DARLING HARBOUR LIVE (DHL)
THE HAYMARKET
SUPPLEMENTARY PUBLIC DOMAIN DESIGN REPORT FOR SSDA 4

JANUARY 2014

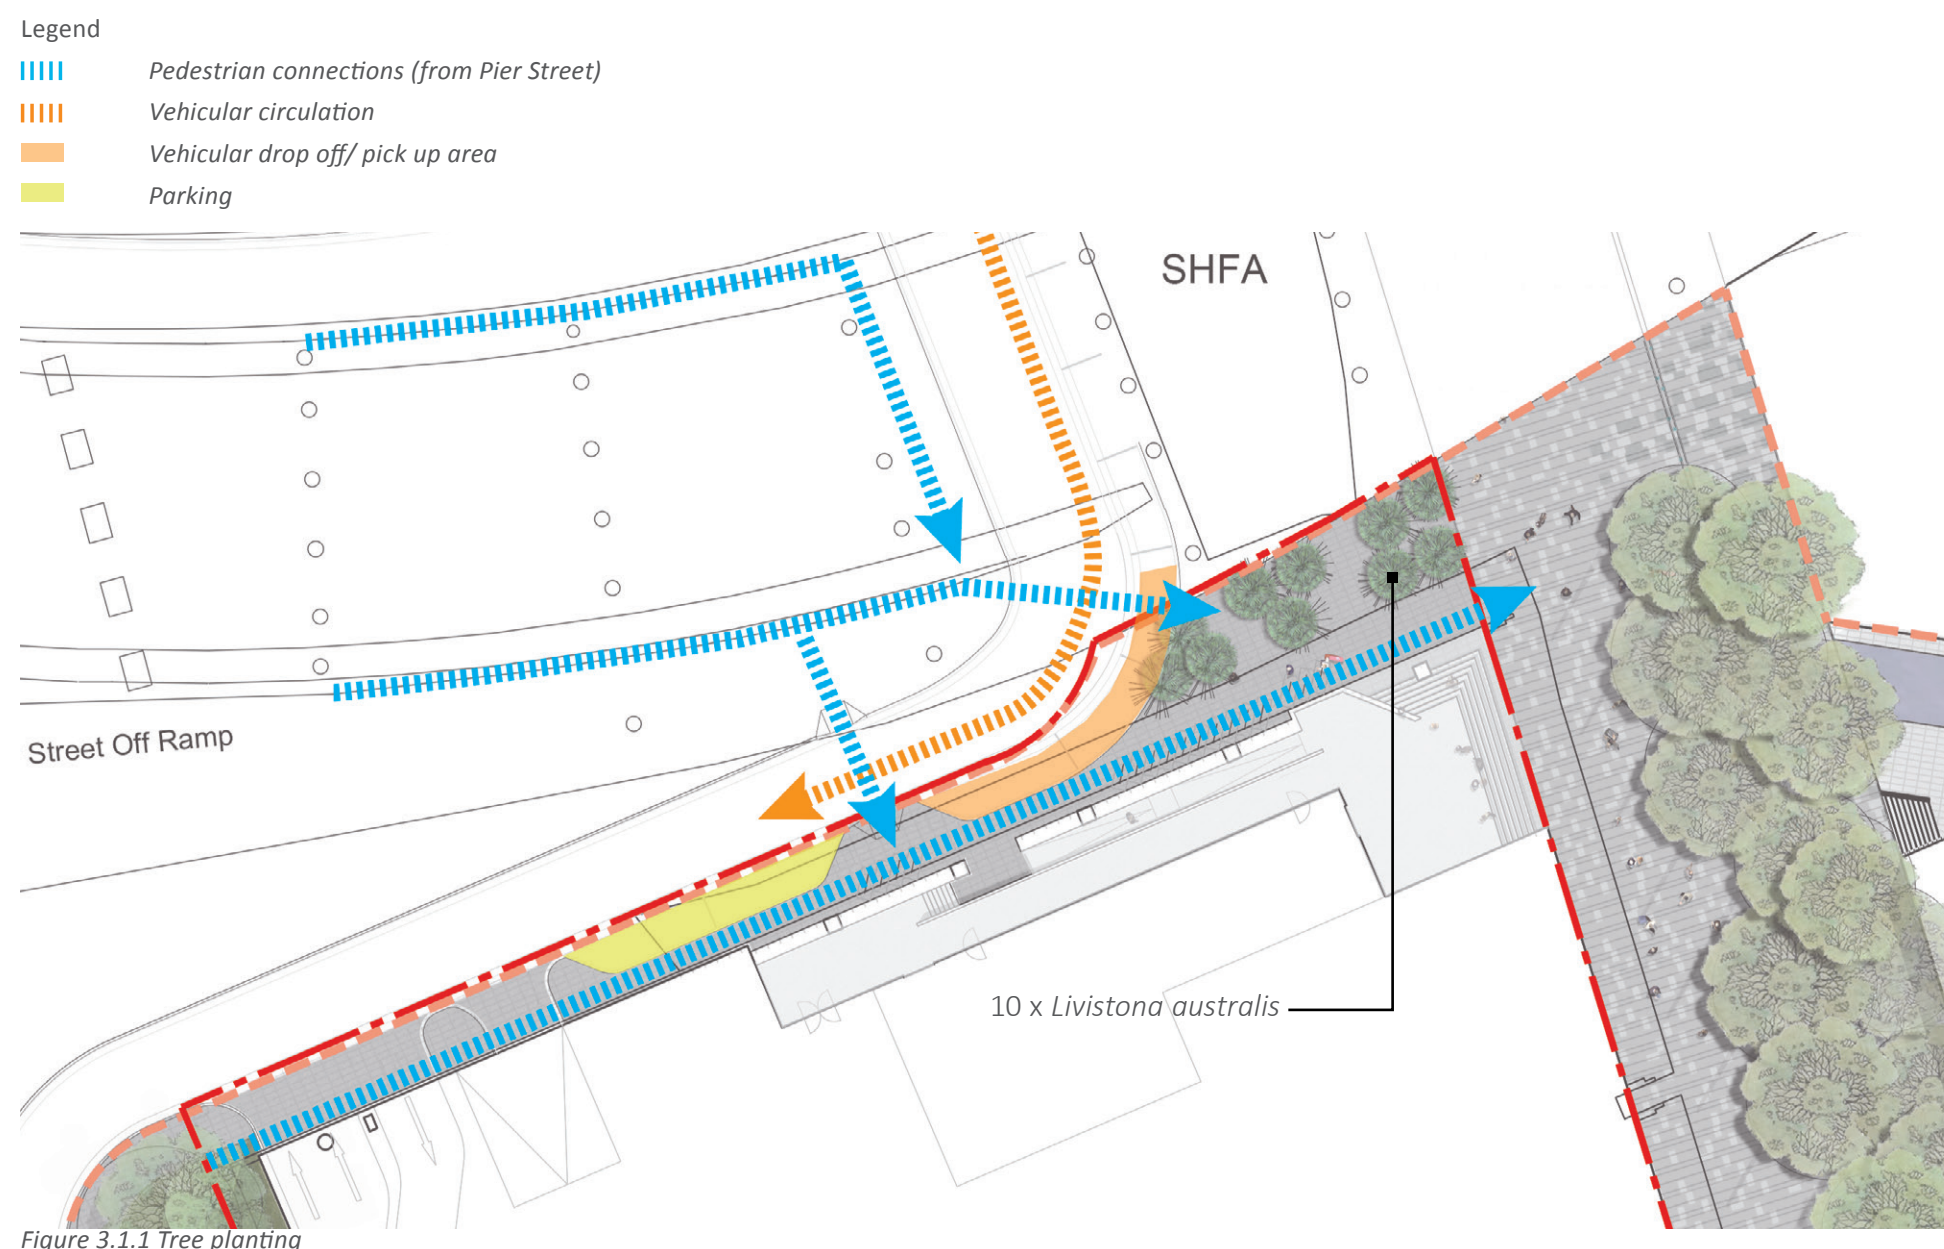
36. New tree planting along the northern frontage of the building should be included in the scope as per the DHL Concept Plan for the southern precinct. A row of *Agathis robusta* is recommended to replace the single, slow growing *Magnolia grandiflora* 'Exmouth' tree currently shown.

Where necessary, the northern façade of the building should be set back to accommodate the tree planting.

c. The Department notes that the proposed planting along the northern boundary of the NW Plot has been reduced from a row of 11 trees (as suggested within the Public Domain Concept Proposal), to a single tree located adjacent to the boulevard. Justification for the reduction is required and consideration should be given to additional tree planting in this location.

Upon further detailed design review following the CoS submission a group of *Livistona australis* is proposed in this area. The plant selection reinforces the site wide theme and reference to the historical landscape. The proposed palm grove will tie in with the language of 'gullies' throughout the site - similarly to Harbourside Place and Tumblong Place in the PPP development - and will ensure a level of consistency to unify the DHL precinct and improve the intuitive wayfinding of the area.

The CoS proposal of *Agathis robusta* is not deemed appropriate for the following reasons:

- Its height (30-50m) is of a too large scale and competes with the strength of the Boulevard avenue;
- The establishment of a regular habitus, desirable for a feature tree, is too unpredictable for this species and within this spatially restricted environment in between overpass and building; and
- It is not native to this area.

Due to realignment of the road (refer to PPP SSDA1 application), a row of trees to the Northern facade is no longer possible. The proposed *Livistona* grove will however not only provide arrival address to the precinct and North West building but also allow for through sight lines for pedestrian movement off Pier Street and allow maintenance vehicle access around and under (refer figure 3.1.1.).

Figure 3.2.1 Excerpt from 'Cycle Strategy and Action Plan. 2007 - 2017' - Proposed regional network.

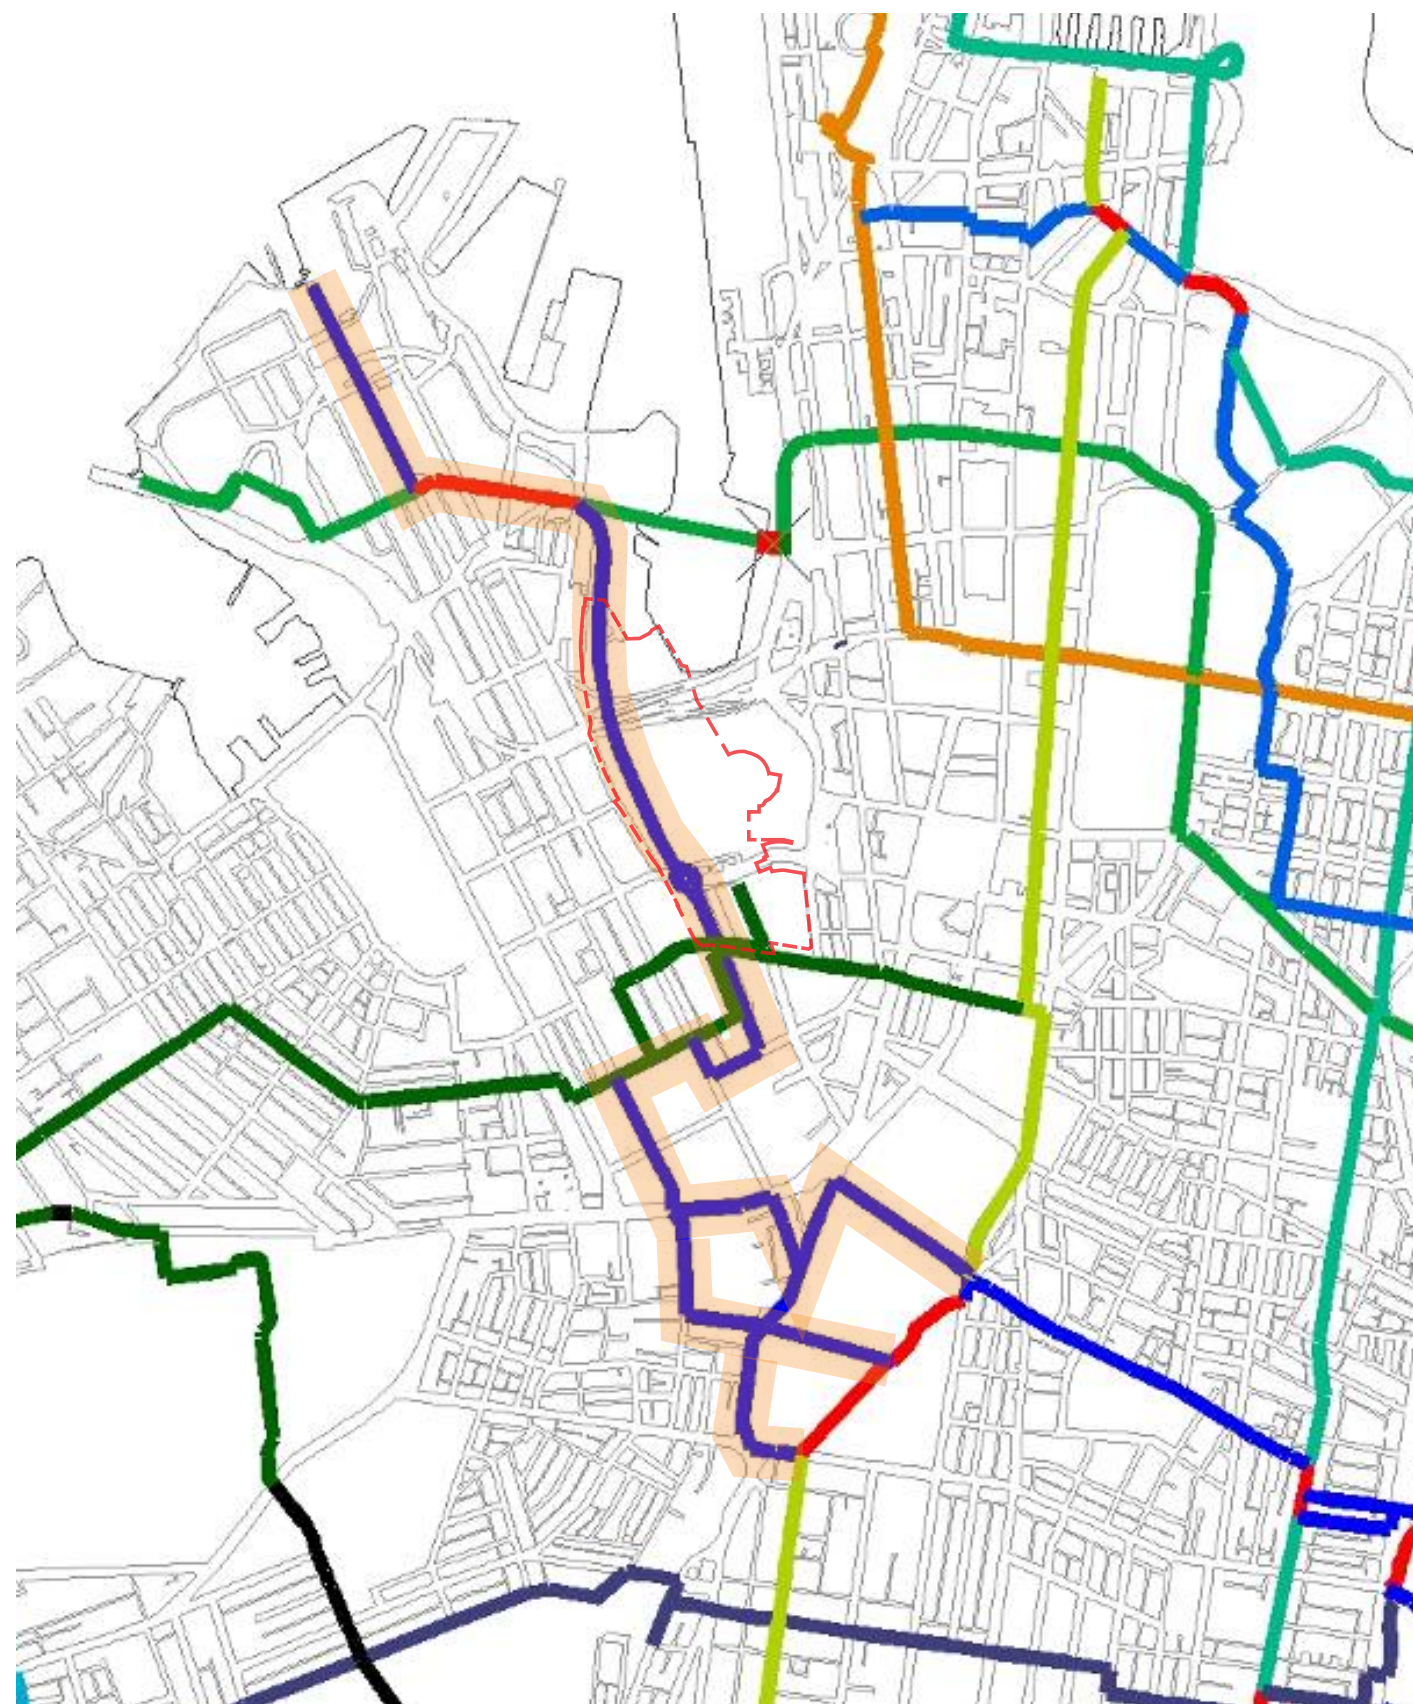
3. The proposed cycle routes should be reviewed for consistency with the current regional bike route network.

The SSDA4 and overall Southern Precinct proposal tie in with City of Sydney's 'Cycle Strategy and Action Plan. 2007 - 2017'. The proposed Darling Drive dedicated two- way cycle path, which transitions into a shared path in between Tumbalong Place and Hay Street, will form part of the proposed R8 Pyrmont to Moore Park regional cycle route.

Figure 3.3.1 Section through WSUD area

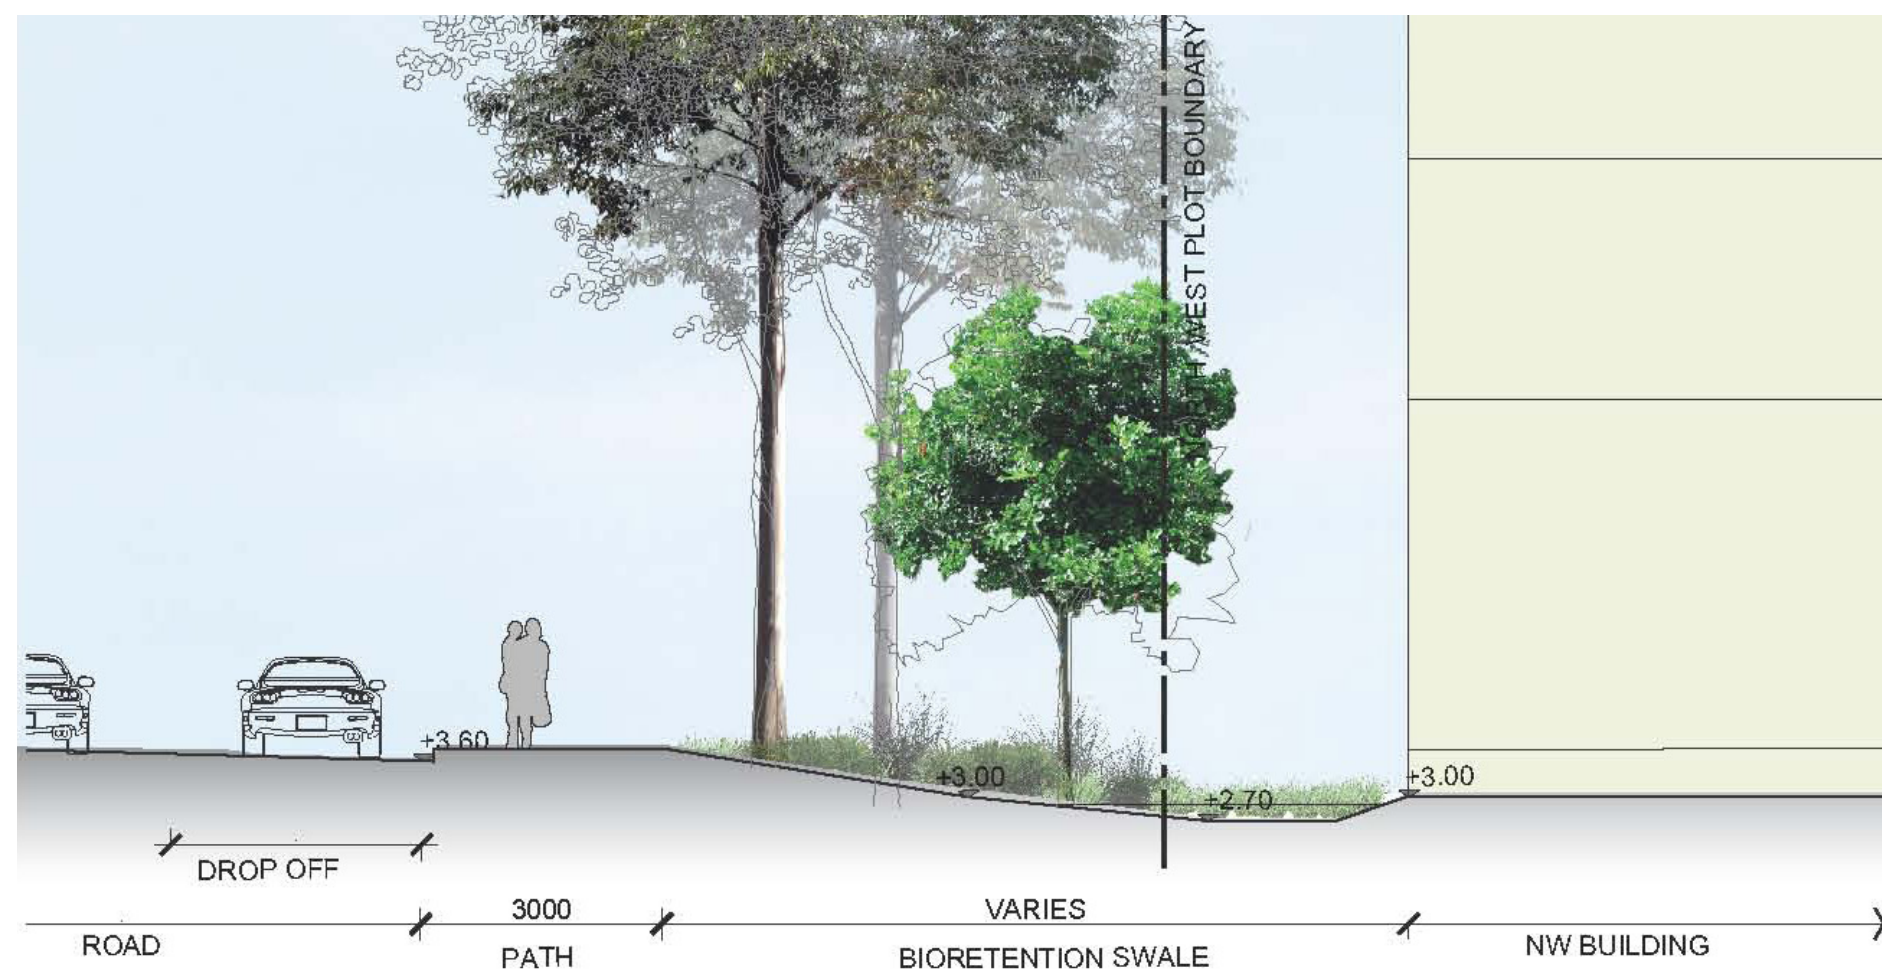
37. The western side of the development have CCTV monitoring and lighting where the footpath abuts the landscaped area.

11. The Department considers that the security of the western side of the development where it abuts the landscaped area and the bicycle storage should be improved. The Department notes Council's comments seeking improvements in this regard.

The proposal has been reviewed in response to CPTED concerns and adjustments have been made to improve sight lines and passive surveillance whilst maintaining the functionality of a WSUD area.

The path has been moved away from the building face to improve surveillance and sightlines. As such the WSUD zone has been shifted to the building face and the path moved adjacent to Darling Drive (to be provided as part of SSDA5). This realignment allows for rationalised pedestrian movement, servicing of the dropoff bay and an improvement of safety and sight lines.

Surveillance is provided from the student housing and passing traffic. Safety is further ensured through low level planting and adequate lighting provided from Darling Drive street lighting.
